Re: ACP 324277 – Response to An Taisce Observation on the Substitute Consent Application at Ardcahan, Dunmanway, Co. Cork

Applicant Response to An Taisce Observation

Appendix A – Combined Substitute Consent Remediation and S37L Regeneration Plan

Ardcahan Quarry Development – RFI Clarification Responses.

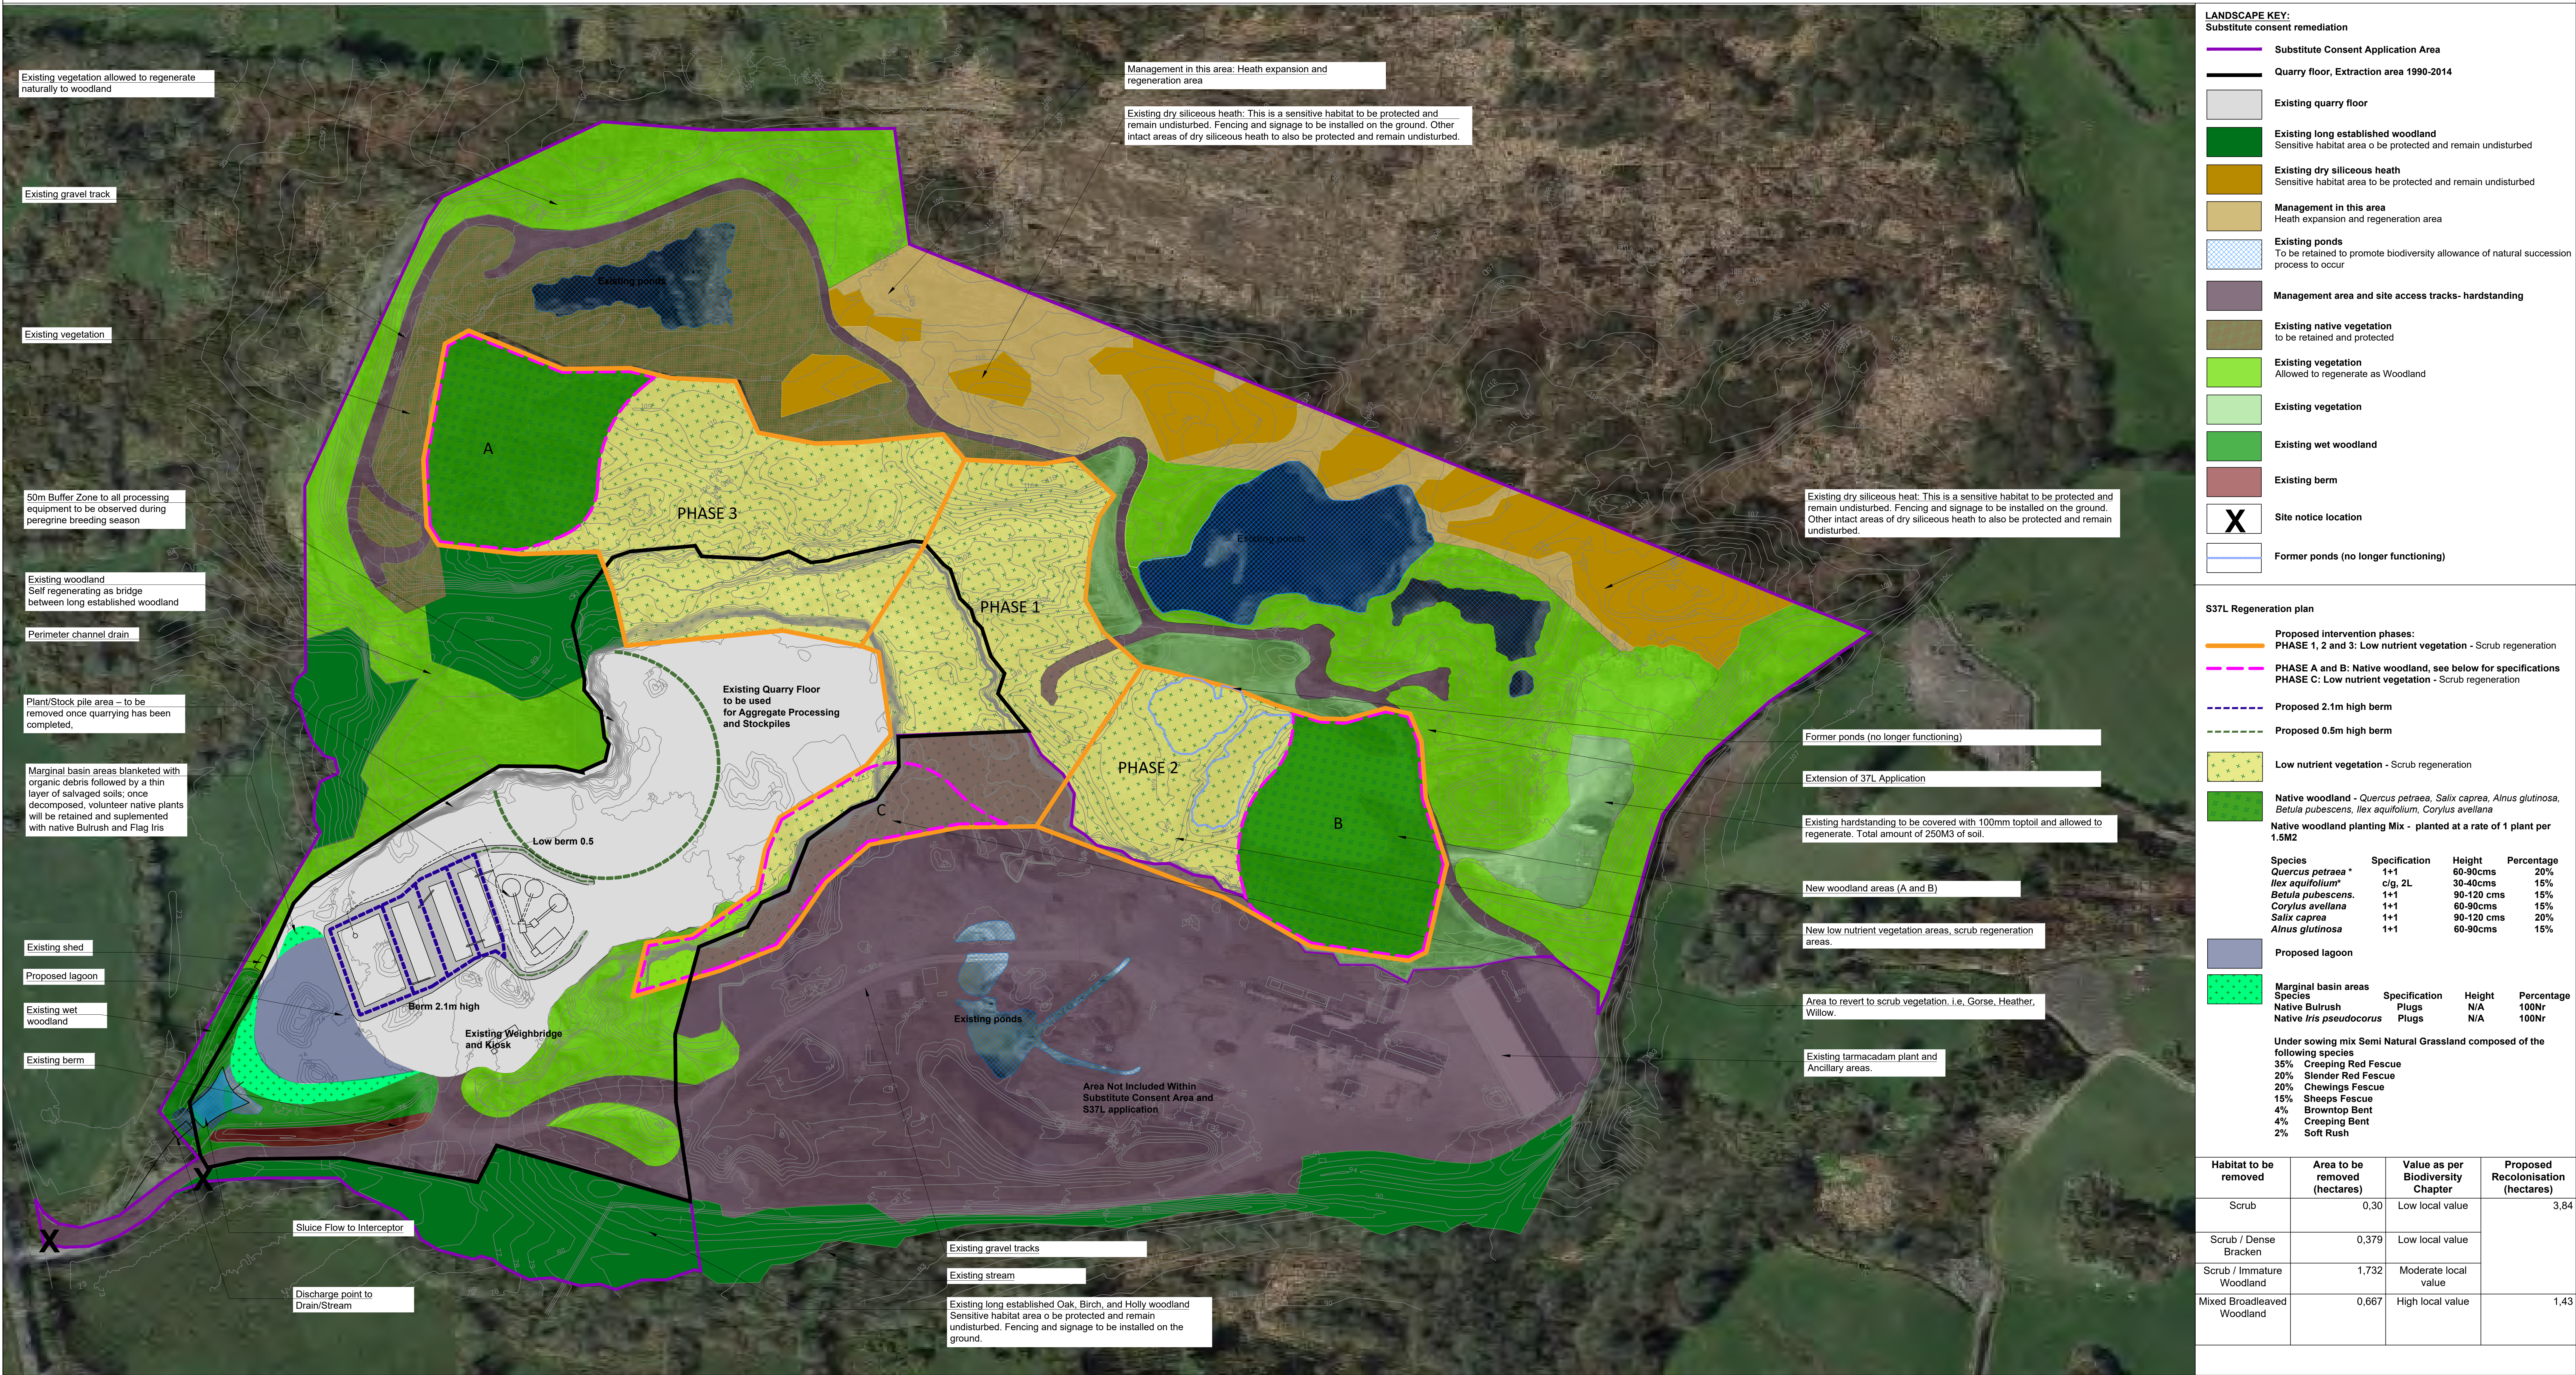
The interaction between the Substitute Consent Remediation Plan and the Section 37L Regeneration Plan is illustrated in the combined landscape drawing, which was submitted in response to the council's report and is appended to this letter response.

This landscape plan proposes landscape remediation measures to address significant landscape and visual related effects that have occurred between 1990 and 2014. The rEiAR identifies the historic habitat losses associated with quarrying activity and proposes a comprehensive suite of remedial measures. The guiding framework for this landscape plan is the acknowledgement of the current value of the ecological processes that have generated onsite and the facilitation of this natural succession is incorporated as a sustainable method for landscape and habitat restoration (See points 1-4 below). However, this is not merely a passive concern. Active processes such as Ecological monitoring and Invasive species monitoring and control will be engaged to promote landscape remediation (see points 5,6 below).

- Once quarrying activities have ceased, it is proposed to use the previously excavated site topsoil (phases 1, 2 and 3) to facilitate the establishment of new woodland habitats. The addition of approx. 250mm of topsoil will facilitate the expansion of these fragmented woodland habitats. These areas have been identified to support the expansion of the Existing Long Established Woodland in the Remediation Plan, Area A, and also Area B in the S37L Regeneration Plan.

- A further area, Area C, has been identified as a transition scrub area in the supporting ecological report and this will be facilitated with the spreading of approx. 100mm of topsoil over the area. No imported seed will be brought into this area to facilitate the development of low nutrient scrub vegetation (ie Gorse, Heather and Willow).

- Incorporation of Marginal wetland basin planting as a landscape transition from the lagoon. The planting of pockets of native wetland vegetation including Bulrush and Native Flag Iris will support the development of Marginal Wetland Planting as will the sowing of a native Seminaturl grassland understorey.
